STATE OF NORTH CAROLINA
DEPARTMENT OF TRANSPORTATION

SUBJECT: Proposed improvements to Weaver Dairy Road (SR 1733), from NC 86 to Erwin Road (SR 1734) in Chapel Hill, Orange County, Federal Aid Project No. MASTP 1733(11), State Project No. 8.2501601, TIP Project No. U-3306

Attachment: Alternative 1A Revised Cross Section

ALTERNATIVE 1A REVISED

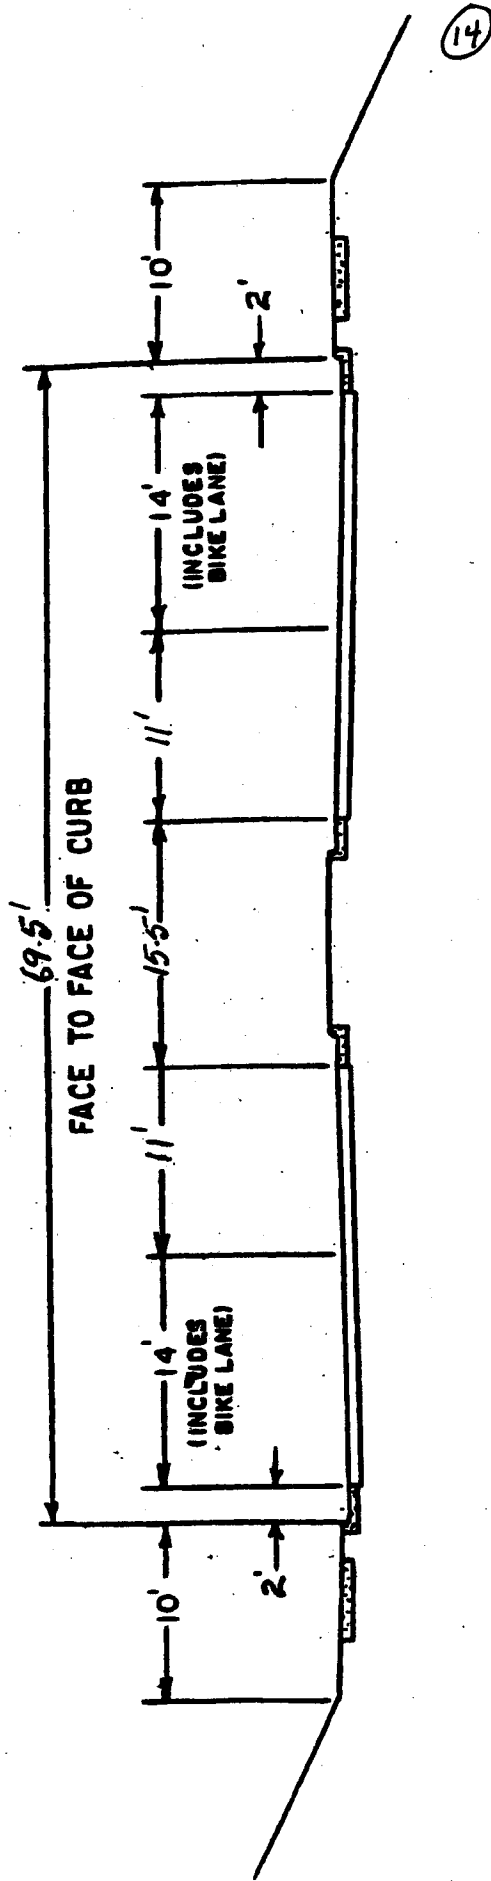
After due consideration from all pertinent perspectives, it was determined that the NCDOT would not recommend construction of a three-lane project as endorsed by the Chapel Hill Town Council. It is the State's opinion that a three-lane project would not adequately meet the projected service and safety needs of this important transportation corridor. The NCDOT recommends construction of a four-lane divided cross section as outlined in Alternative 1A Revised (see Attached Cross Section).

This is the alternative that the Town Manager recommended to the Town Council at the regular meeting on January 22, 2001. This alternative calls for a four-lane median divided cross section consisting of: two travel lanes in each direction with wide outside lanes to accommodate bicycle use, a narrowed raised center median with exclusive turn lanes and refuge areas for pedestrians, sidewalks along both sides of the roadway, and bus pull-offs as necessary.

Alternative 1A Revised, which was developed by the NCDOT in conjunction with Town staff, would best address the concerns of all parties and would meet the long-range transportation plans for the area. We believe that this alternative would be safer than a three-lane cross section because it would best tie together the existing improvements (previously constructed by private developers as required by the Town) and would create continuity between different sections of the project corridor, thereby most reasonably accommodating drivers' expectations. Traffic safety would also be improved by including a center median in the project, which would separate traffic flow, allow for exclusive left turn lanes, and provide crossovers at logical locations.

Pedestrian safety would be enhanced by the refuge area created by installation of a center median, which would allow pedestrians to cross only half of the roadway (two travel lanes, both in the same direction) at a time. Additionally, the center median would provide landscaping opportunities to both beautify the roadway corridor and to eliminate the potential "runway" appearance of a three-lane or five-lane undivided cross section.

This State recommended design alternative would provide a high level of service (traffic capacity) for motorists in the design year (2025) which could not be achieved with a three-lane cross section. Also, a three-lane cross section would require supplementary improvements such as exclusive right turn lanes to maintain even marginal traffic capacity in the design year, and therefore raises serious concerns as to its viability as an acceptable long-range transportation solution for the Weaver Dairy Road corridor.

The preliminary design for the State approved alternative (Alternative 1A Revised) indicates two more impacts to residences than would occur with a three-lane cross section as endorsed by the Town Council. However, we think it is possible that these and other impacts could be avoided by careful and creative engineering during the design phase of the project. The revised four-lane divided cross section proposed by the Town Manager and the State would maximize the function, safety, and aesthetics of the improvements with minimal impacts on the project corridor.
